COUNCIL REPORT

SUBJECT: Improvements to Roofing Installation Requirements

APPENDIX A**DRAFT By-law to amend Building By-law No. 12511
Regarding Roofing-Related Requirements**

Figure A-1.4.1.1. Roof terminology

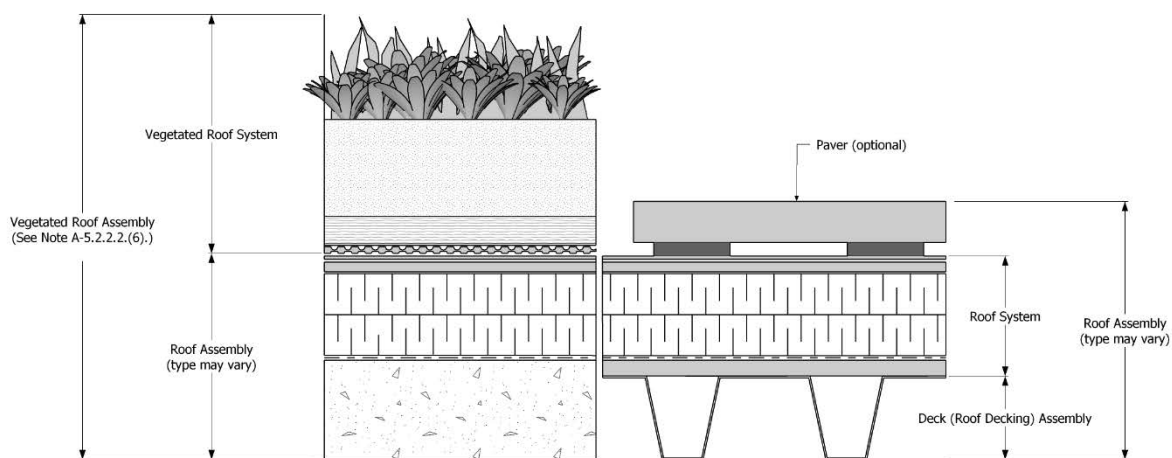
- (b) removes the asterisk from the definitions of “Clear-water waste”, “Drainage system”, “Floor drain”, “Storm building drain”, “Storm water”, “Subsoil drainage pipe”, “Sump”, “Trap”, “Venting system”, “Water distribution system” and “Water service pipe”.
5. In the Notes to Part 1 of Book I, Division A, Council adds a new note:

“A-1.4.1.1. Non-defined Terms.

Roof terminology

Where the By-law addresses the separation of environments (Part 5 and Part 9), various terms refer to the assembly on top of a building that protects the building interior from the weather. In general terms, that assembly is called a “roof assembly” (or more simply, a “roof”). A roof comprises two integrated parts: the “deck assembly” (a structural element of a building, also referred to as the “roof decking assembly”), and the “roof system” (Figure A-1.4.1.1.). The requirements of this By-law generally refer to the “roof assembly” and not the “roof system”; for example, the “roof assembly” must resist wind load (see Article 5.2.2.2. of Division B).

When materials that seal the roof to resist the transmission of liquid water into a building are constructed on a roof deck — including water under some hydrostatic pressure — they form a waterproofing roof assembly. Waterproofing materials are usually manufactured as rolled sheet goods or as liquids; installation methods are specified by the manufacturer and often governed by published standards (for example, standards by ASTM and the Roofing Contractors Association of British Columbia). Waterproofing roof assemblies can be constructed on any slope but are generally intended for horizontal or near-horizontal applications. Roofs constructed with rolled sheet membranes are those referred to in Sentence 5.2.2.2.(4) of Division B.

Generally, waterproofing roof assemblies can be configured in one of two ways. “Conventionally insulated” roof assemblies (also referred to as “compact roofs”) are constructed with the weatherproofing material (membrane) on top of the assembly. The membrane therefore shields the insulation and all other assembly components from the weather. In “protected” roof assemblies, the membrane is located immediately above the roof deck and is therefore protected by insulation and other roofing components that are made to be exposed to weather. The configuration of the roof assembly determines the appropriate selection of its materials, including the membrane. A third, “hybrid configuration” (sometimes called a “modified protected” roof assembly) is less common and combines a protected system on top of a conventional assembly, to utilize the benefits of each.

Many waterproofing roof assemblies provide a suitable platform for rooftop amenities, a vegetated roof system, or other types of overburdens. Careful consideration must be given to superimposed loads, to avoid compression and distortion of the roofing materials, which can compromise the waterproofing. Where any overburden is intended for sloped applications, the design must incorporate anti-shear measures.

Water-shedding roof assemblies are typically constructed with a slope equal to or greater than 1:4 (3” in 12”), include curved or barreled forms, and are designed and constructed with weatherproofing materials that interlock or overlap, relying on gravity and slope to shed water away from a building, usually into an arrangement of gutters. These assemblies may be insulated, when configured appropriately for ventilation. In Vancouver, most water-shedding roofs are built with asphalt shingles, cedar shingles or shakes, or metal panels.
